# Access Compliance Report

## Public Rights-of-Way

### (Curb Ramps)

Intersection ID: 15243	Main Street: ALBEMARLE_RD	Cross Street: REGAL_OAKS_DR	Location: NE
ADA ID: 9756B3C8E306	Ramp Type: PerpDiag	Initial Pass/Fail: Fail	Overall Compliance: No
Severity Score: 12.5			
Codes/Mitigation Info/Possible Solution		Field Measurements/Component Compliance

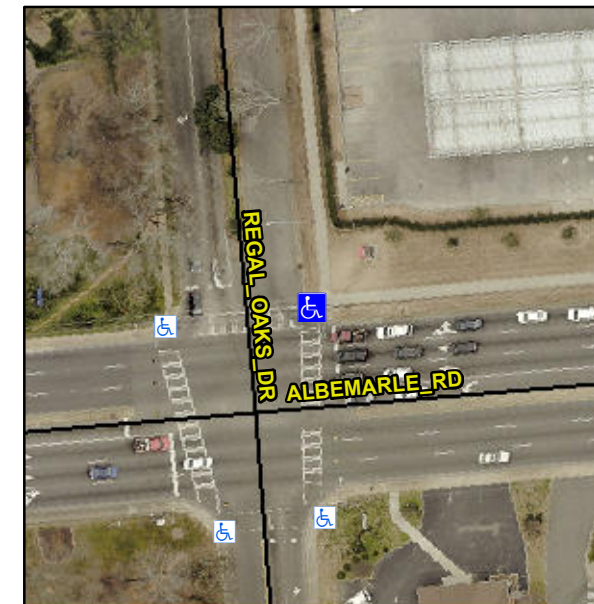
**Not Found, R304.2.2**

Compliance	Description	Data	Compliance	Description	Data
N/A	Ramp Length (in)	65.0	No	Ramp Slope (%)	10.6
Yes	Ramp Width (in)	48.0	Yes	Ramp XSlope (%)	0.4
N/A	Flare Type LT	N/A	N/A	Flare Type RT	N/A
N/A	Flare Slope LT (%)	N/A	N/A	Flare Slope RT (%)	N/A
N/A	Flare Traversable LT?	N/A	N/A	Flare Traversable RT?	N/A
N/A	Landing Length (in)	N/A	N/A	DWS Provided?	N/A
N/A	Landing Width (in)	N/A	N/A	DWS Contrast?	N/A
N/A	Landing Slope (%)	N/A	N/A	DWS Length (in)	N/A
N/A	Landing X Slope (%)	N/A	N/A	DWS Full Width?	N/A
N/A	Landing Curb? (Y/N)	N/A	N/A	DWS Offset (in)	N/A
N/A	Shared Landing?	N/A			
N/A	Gutter Ponding?	N/A	N/A	Gutter Slope (%)	N/A
N/A	Gutter Lip Ht (in)	N/A	N/A	Gutter X Slope (%)	N/A
N/A	Painted X Walk1?	Yes	N/A	Painted X Walk2?	Yes
	X Walk 1 Direction	To W		X Walk 2 Direction	To S
N/A	X Walk 1 Width (in)	116.0	N/A	X Walk 2 Width (in)	108.0
	X Walk 1 Slope (%)	1.0		X Walk 2 Slope (%)	3.2
	X Walk 1 X Slope (%)	1.7		X Walk 2 X Slope (%)	1.6

**Remove & Replace Curb Ramp With Two New Directional Ramps or Equivalent.**
